From: registrar < registrar@oeb.ca>
Sent: Tuesday, February 9, 2021 9:35 AM
To: Janet Sakauye < Janet.Sakauye@oeb.ca>
Subject: FW: EB-2020-0265 Hawthorne to Merivale Project Hydro One

From: Rupert, Barbara <<u>Barb.Rupert@yow.ca</u>>
Sent: Monday, February 08, 2021 12:17 PM
To: HAULENA Adam <<u>Adam.Haulena@HydroOne.com</u>>
Cc: 'Rudra Mukherji' <<u>Rudra.Mukherji@oeb.ca</u>>; 'registrar@oeb.ca' <<u>registrar@oeb.ca</u>>; Mathurin,
Marcel <<u>marcel.mathurin@yow.ca</u>>; ENGELBERG Michael <<u>mengelberg@HydroOne.com</u>>
Subject: EB-2020-0265 Hawthorne to Merivale Project Hydro One

Further to our discussions last week, and following review of the Airport Zoning Regulations (AZR) for Ottawa, it appears that a significant portion of the Hydro One Hawthorne to Merivale reconductoring project area falls within its bounds.

Below is a screen capture of the AZR Outer surface (red fill) and the hydro corridor (boxed in).

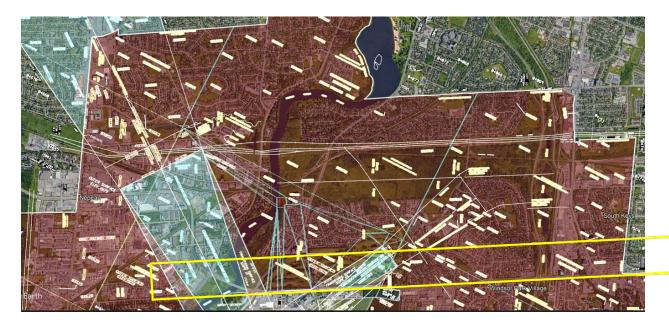
The Hydro One corridor between Merivale Road in the west and Bank Street to the east is within the *Outer Surface Boundary.*

Note the Outer Surface is at an elevation of 151.79m ASL CGVD28.

The OMCIA is highlighting these restrictions for consideration. Since the lands are located under the AZR, Hydro One **must** submit a **Transport Canada Aeronautical Assessment Form** and a **NAV CANADA Land Use proposal**. Should the process of completing these works exceed the height of the AZR, an exemption from Transport Canada (TC) will be required. A requested exemption has an attached cost, could take in excess of three months to complete and may ultimately be rejected by TC. The OMCIA recommendation to Hydro One is to plan on adhering to the elevation limitations set out in the AZR, and consulting with NAV CANADA to ensure that no interference with communication exists.

Hope things are well with you. I ran some of the information you provided across our engineers. I've also provided a photo of the crane type that would be used for the reconductoring work. We submitted the NavCanada package including the attached obstacle sheet on Friday. Reviewing the plan and profile drawings for these towerlines, I see the airport outer surface elevation limit of 151.8m for the following towers:

- South Line (M31A)
 - o 686 to 708
- North Line (M30A)
 694 to 716

Looking closely at the image below, I believe the two towers that do exceed the 151.79m above sea level limit (712-S, 720-N) in the obstacle form are actually outside the highlighted elevation limit area.
